Re: Petition No. 1339 – Petition of Wallingford Renewable Energy LLC for a Declaratory Ruling that no Certificate of Environmental Compatibility and Public Need is Required for a 19.99 MW AC Solar Photovoltaic Electric Generating Facility in Wallingford, Connecticut

Petition of Wallingford Renewable Energy LLC
for a Declaratory Ruling pursuant to C.G.S. §4-176
and § 16-50k, for the proposed construction,
maintenance and operation of a 19.99 MW AC
ground-mounted solar photovoltaic electric
generating facility located on approximately
158 acres of 3 contiguous parcels consisting of
the former Wallingford Landfill and 2 parcels
owned by the Materials Innovation and Recycling
Authority west of Pent Road and associated
electrical interconnection to Wallingford Electric
Division's Wallingford Substation in
Wallingford, Connecticut

**WALLINGFORD RENEWABLE ENERGY LLC'S RESPONSES TO
THE CONNECTICUT SITING COUNCIL'S FIRST SET OF INTERROGATORIES**

Exhibit 2 – Revised Figure 24

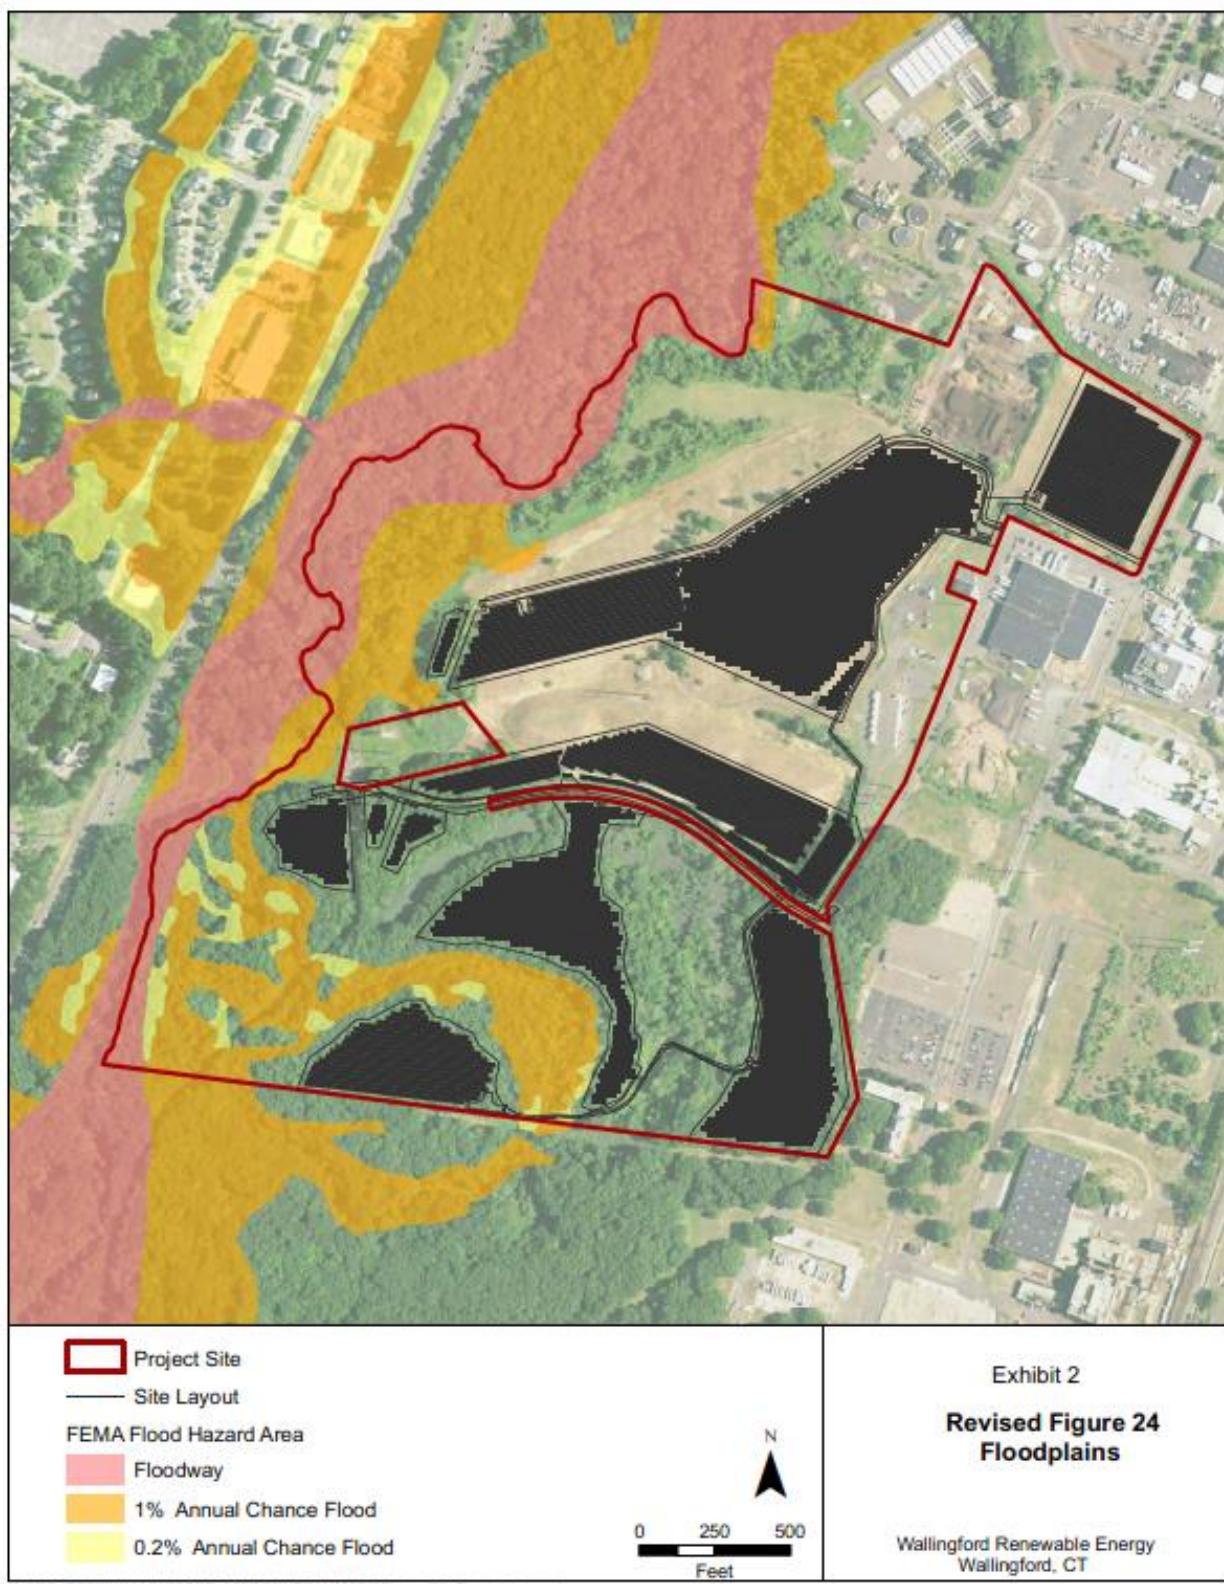
26. Under Appendix A of the Petition, page 10 of the Stormwater Pollution Control Plan notes that, “The Project will not locate features within the 100-year floodplain...” Is any portion of the proposed project located within the 500-year flood zone? If yes, indicate which portion(s) of the project area are located within such flood zones, and provide a Federal Emergency Management Agency flood zone map that includes the subject property. Also, if yes, could the solar panel support posts withstand flood inundation? Would the inverters, panels or wiring be damaged as a result of flood inundation? Would only solar panels be located within the 500-year flood zone, or would equipment pads (e.g. inverters and transformers) be located in such areas also?

The floodplains shown on Figure 24 are from the FEMA maps (FEMA Flood Insurance Rate Map No. 09009C (0303J, 0304J, 0311J and 0312J)), with floodway shown in pink (with no portion of the project within this area), 100-year floodplain (1% annual chance flood) shown in gold (with no portion of the Project within this area), and the area between the limits of the 100-year and 500-year floodplain (0.2% annual chance flood) shown in light yellow. As can be seen in Exhibit 2 (an updated Figure 24 that includes an overlay of the proposed Project), no panels are proposed within the mapped floodplain. The only work proposed within mapped floodplain is use of one existing woods road for access that currently extends through the mapped floodplain area; some surface improvements to the existing road are proposed (as further addressed in response to Question 23).

Exhibit 4 – Mapping of bat hibernacula

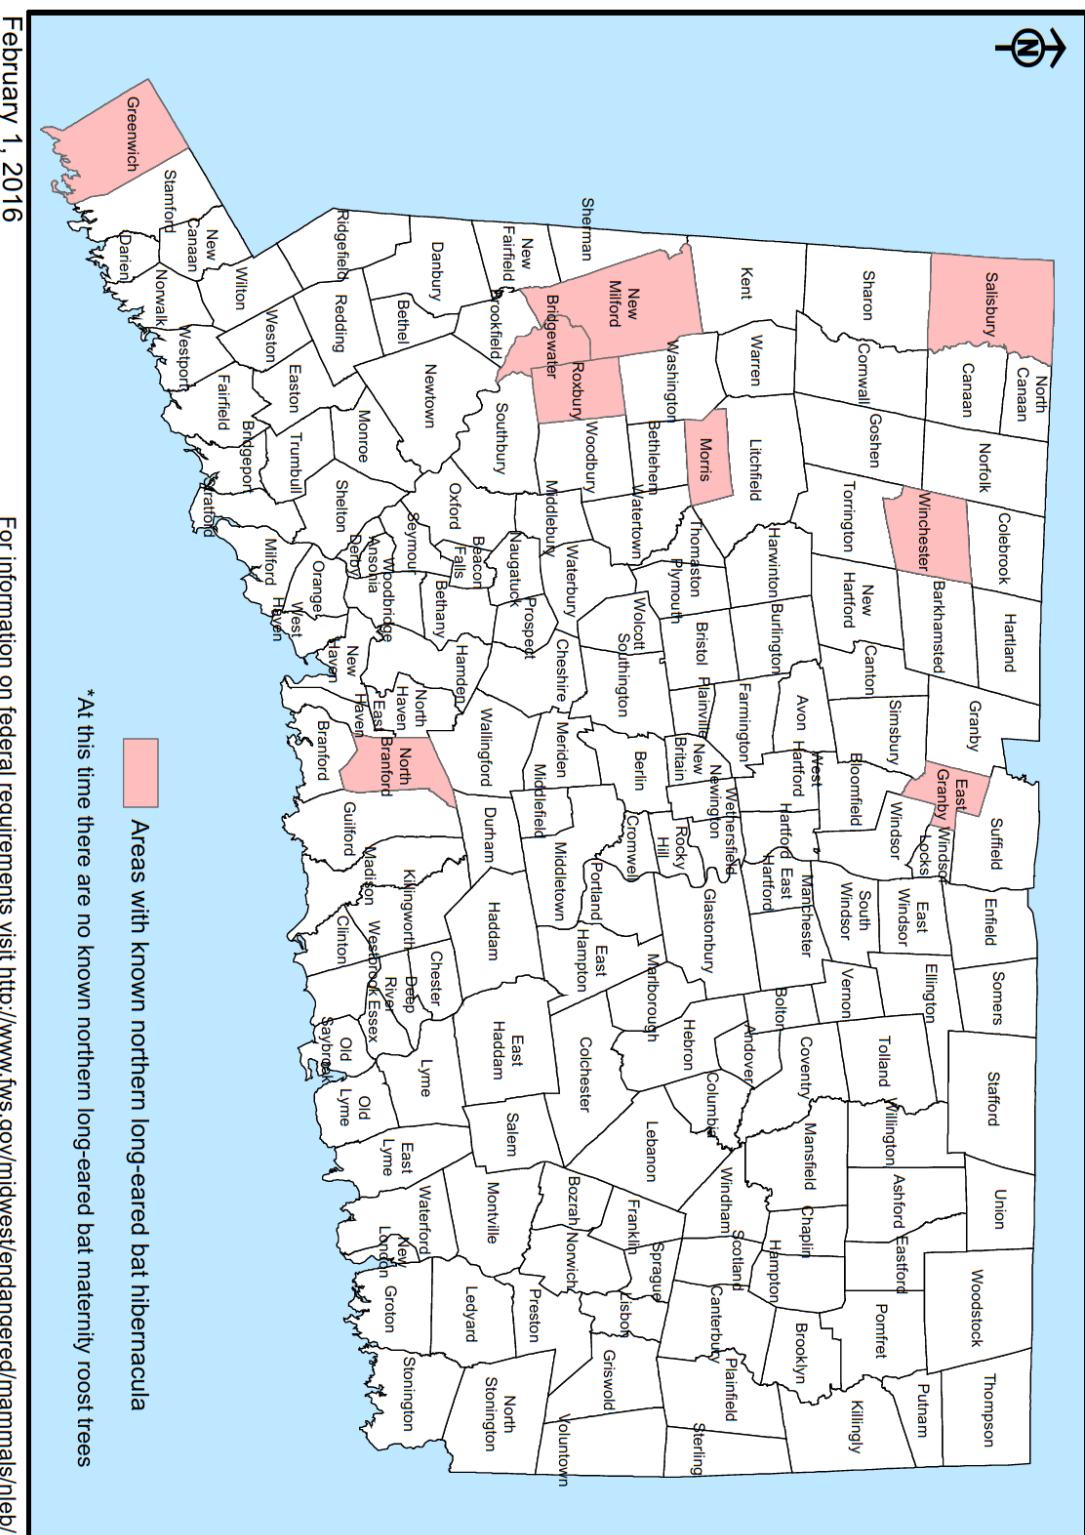
45. Would any proposed tree clearing occur within 0.25 miles of a known northern long-eared bat (NLEB) hibernaculum or within 150 feet of a known occupied maternity roost tree?

According to February 1, 2016 Connecticut mapping (Exhibit 4) no known northern long-eared bat maternity roost trees exist within Connecticut. The closest known location of a northern long-eared bat hibernacula is in North Branford, which is well over 0.25 miles from the closest area of clearing, as the closest portion of North Branford is more than 5 miles from the Project site.
